Chapel Lane, Widnes: Response to Halton BC and Knowsley Council

Ref: VE/ITM19092-002A
Date: 1 May 2025

- 1.1 This Technical Note responds to highways comments received from Halton Borough Council (HBC) and Knowsley Council (KC) in relation to Taylor Wimpey's development proposals at Chapel Lane, Widnes (Outline Application Ref: 23/00244/OUT (HBC); 23/01037/OUT (KC)). The Council's comments were set out in correspondence dated 13th March 2025.
- 1.2 Given the degree of overlap between the two sets of comments, this note seeks to respond to the issues raised in both authorities' responses. This note considers issues relating to the following aspects of the proposals – each is considered in turn below:
- Off-Site Active Travel Package
 - Proposed Access onto Chapel Lane – Primary Access and Emergency Vehicle Access
 - Internal Site Layout
 - Other Issues

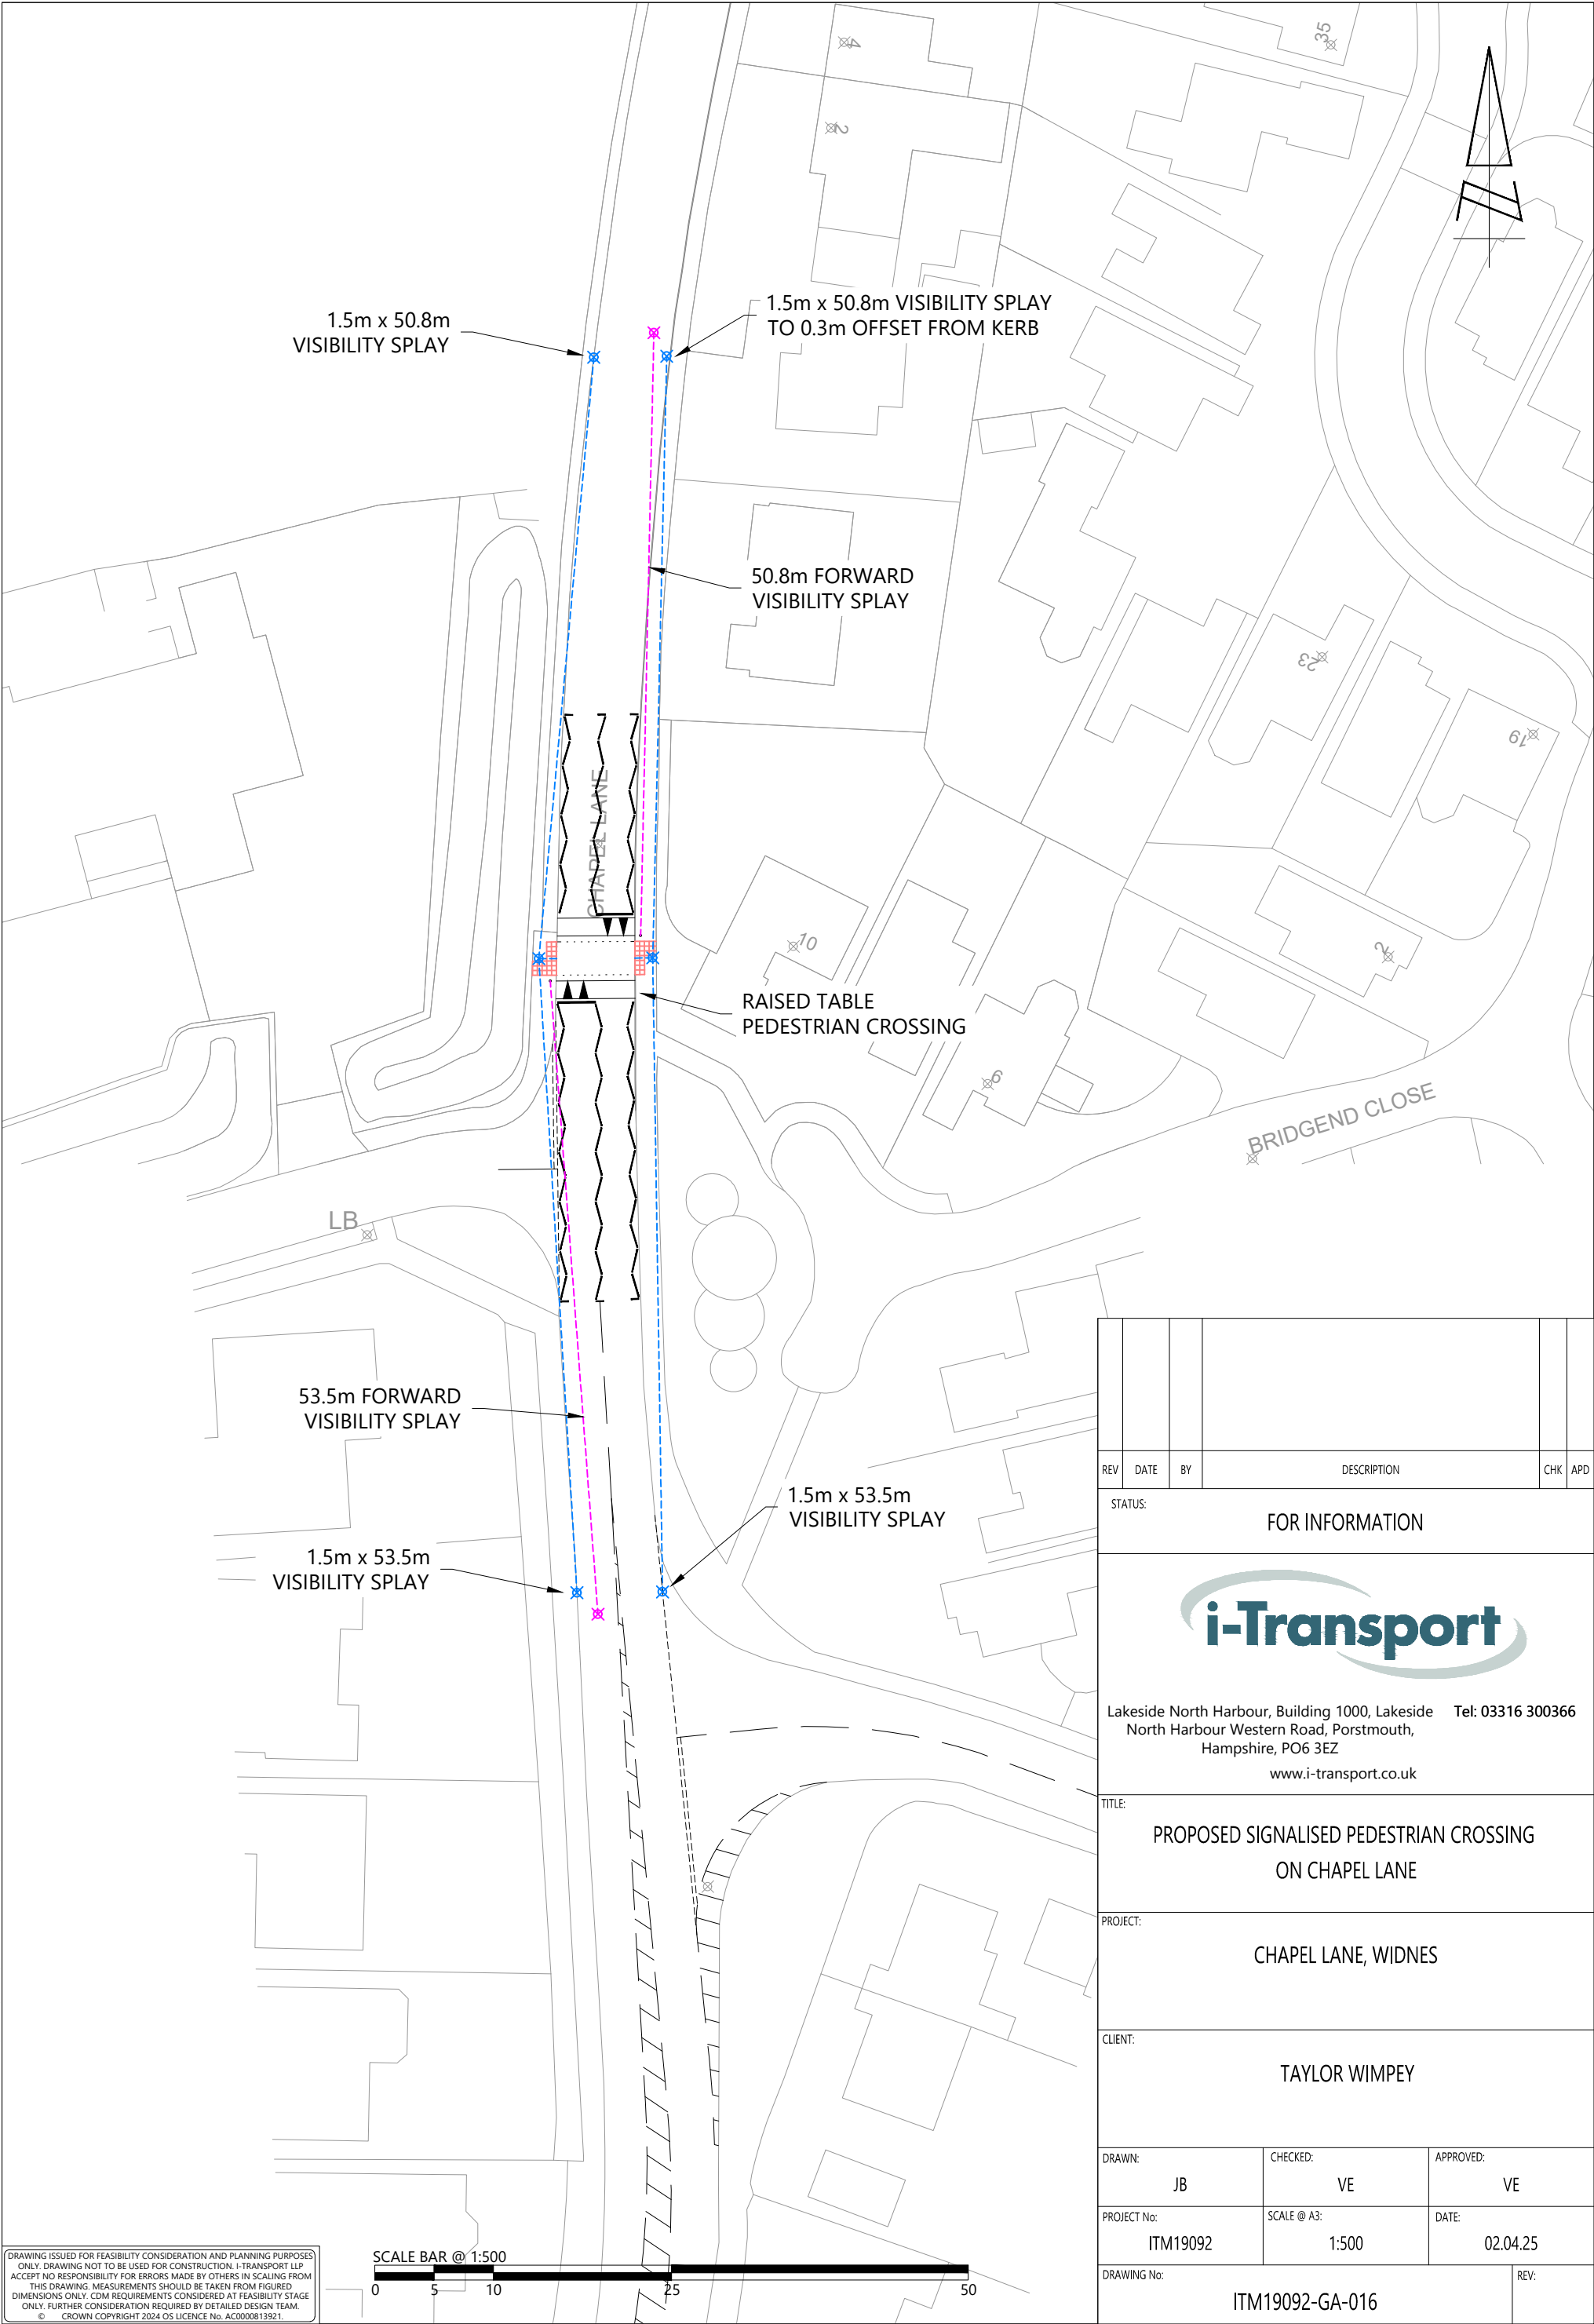
- 2.11 Notwithstanding this, given KC's position that they would not support a zebra crossing in this location, consideration has been given to the provision of a signalised pedestrian crossing in this same location. Drawing ITM19092-GA-016 presented at **Appendix E** shows a signalised pedestrian crossing located to the north of the Parklands junction. The drawing demonstrates that the required vehicular and pedestrian visibilities can be achieved and that a vehicle turning out of Parklands would have sufficient space to wait on Chapel Lane at the crossing.

- 2.12 There is also scope for the proposed crossing to be placed on a raised table, which would further assist in reducing vehicle speeds along this section of Chapel Lane and further highlight the location of the crossing to drivers. This has been allowed for within the costings.

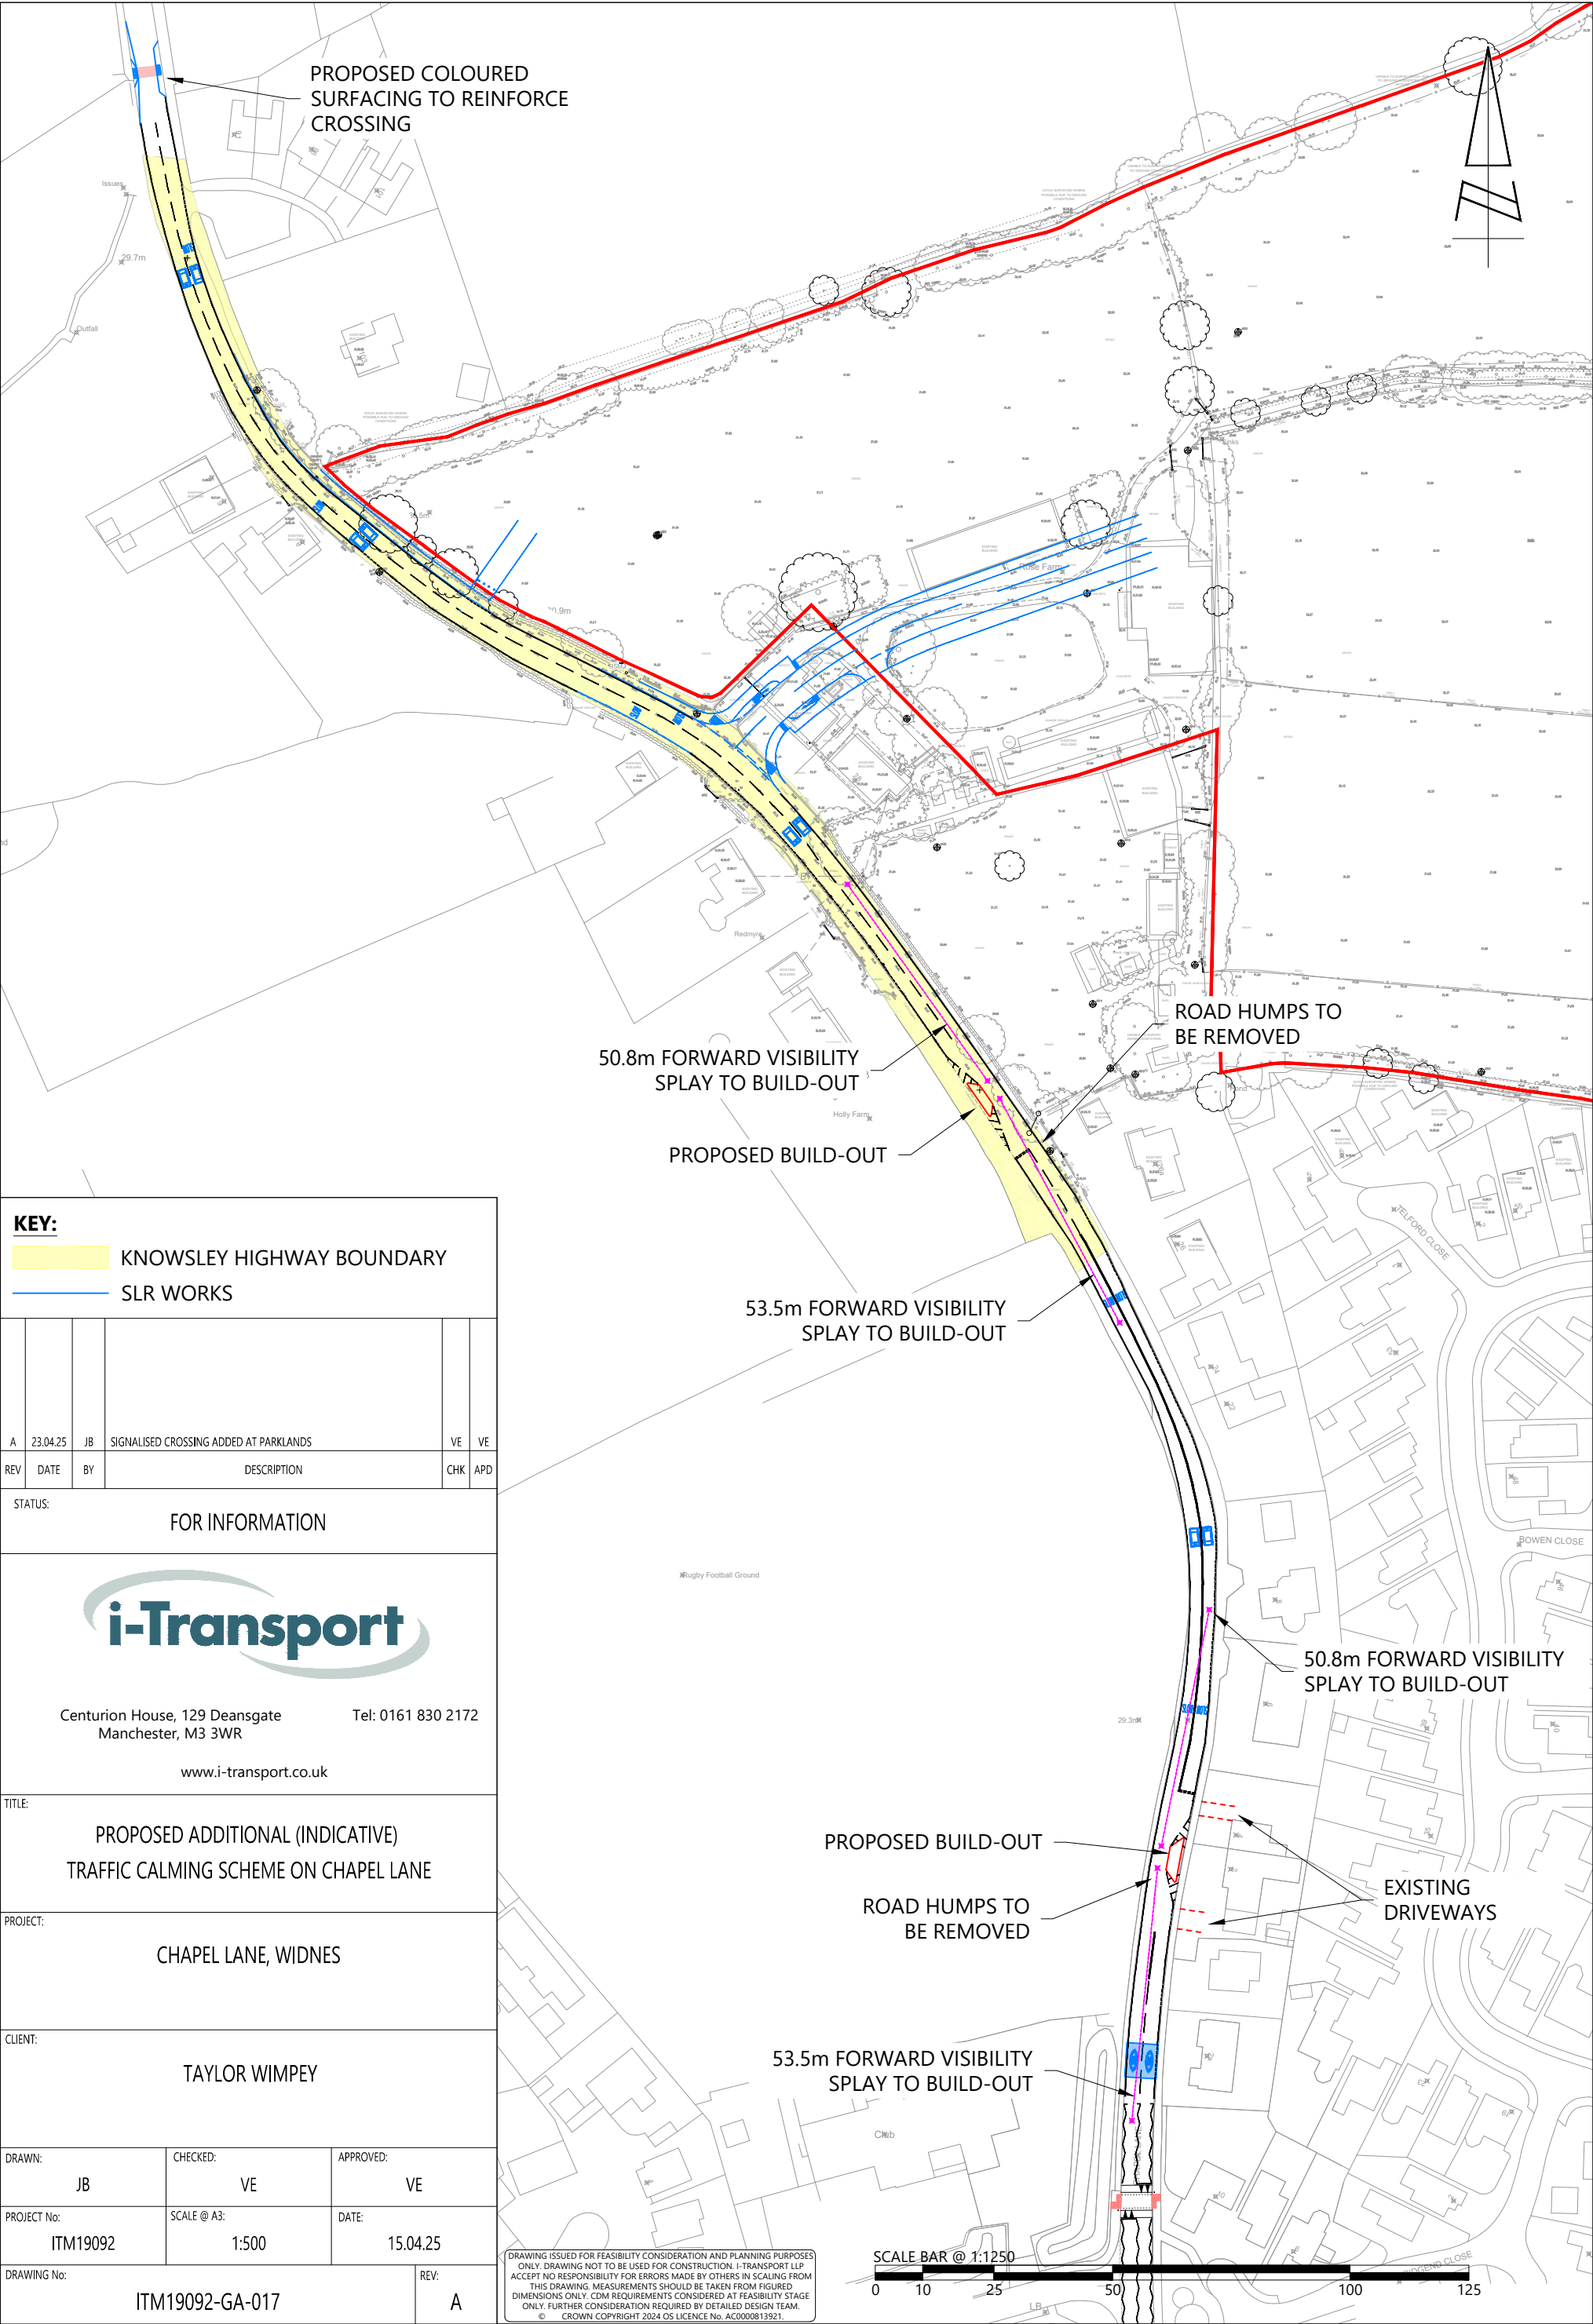
- 2.14 KC has stated that the proposed indicative traffic management plan is unacceptable in its current form but has not indicated their preferred form of traffic calming along Chapel Lane.

- 2.15 Drawing ITM19092-GA-017 Rev A enclosed at **Appendix F** shows the full extent of the proposed traffic calming scheme. This includes the addition of two chicane/build-outs on Chapel Lane, between Parklands and the proposed primary site access and the reinforcement of the proposed build-out at the PROW crossing to the north of the proposed access, with coloured surfacing.

- 2.16 Overall, the proposed traffic calming scheme – which would need to be subject to separate approvals and consultation with the highway authority, as noted in the draft Conditions, would include the following measures over the c.550 metre section of Chapel Lane between the PROW and Parklands:

- 3no. chicane / build-outs with shuttle working operation for traffic including contrasting surfacing at the PROW crossing.
 - 4no. pairs of virtual speed cushions.

- 4no. pairs of (existing) SLOW markings on the carriageway.
 - Creation of 1no. primary access and 1no. EVA into the development site.
 - 30mph speed limit carriageway roundels.

- A proposed signalised pedestrian crossing on a raised table at the southern end of the scheme.
